UNITED STATES PATENT AND TRADEMARK OFFICE

| APPLICATION NO. | FILING DATE | FIRST NAMED INVENTOR | ATTORNEY DOCKET NO. | CONFIRMATION NO. |
|---|-------------|----------------------|---------------------|------------------|
| 10/608,843 | 06/27/2003 | Taekeun Lee | CPAC 1014-4 | 7642 |

Office Action Summary

FIG. 1

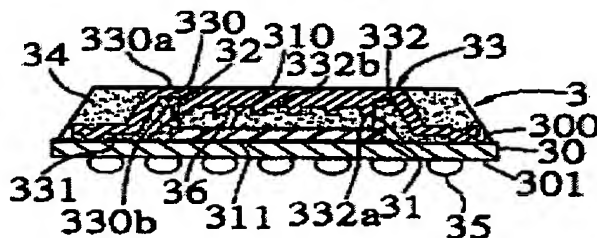
In re claim 1, **Huang** discloses a method for manufacturing a plastic ball grid array package, comprising placing a heat spreader **33** having an upper portion **330a** and a plurality of support arms **331** into a mold cavity, placing over the mold cavity a ball grid array including a semiconductor die **31** mounted on a support surface of a substrate **30** and connected to the substrate, such that lower ends of the support arms contact the support surface **300** of the substrate peripheral to the die; injecting molding material **34** into the cavity; and permitting the molding material to harden to form a mold cap (col. 3, line 53 to col. 4, line 40 and FIGS. 1-7).

In response to Applicants' contention that Huang says nothing as to at least one supporting arm of the heat spreader being affixed to the substrate using a resilient fixative, as recited in the claim, Examiner respectfully disagrees. Applicants are directed to (col. 3, line 53 to col. 4, line 9 and FIG. 1) where Huang discloses that the heat spreader 33 being affixed to the substrate 30 using a resilient fixative.

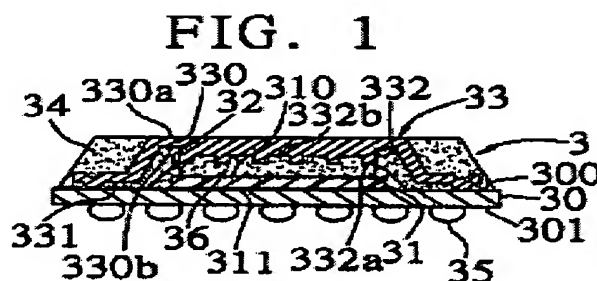
In re claim 10, **Huang** discloses a method for manufacturing a plastic ball grid array package, comprising placing a heat spreader **33** having an upper portion **330a** and a plurality of support arms **331** onto the die support surface **300** of the substrate **30** such that at least one of the supporting arms of the heat spreader is affixed to the substrate using a resilient fixative such as an elastomeric adhesive; placing a mold cavity over the heat spreader; injecting the molding material **34** into the cavity; and permitting the molding material to harden to form a mold cap (col. 3, line 53 to col. 4, line 40 and FIGS. 1-7).
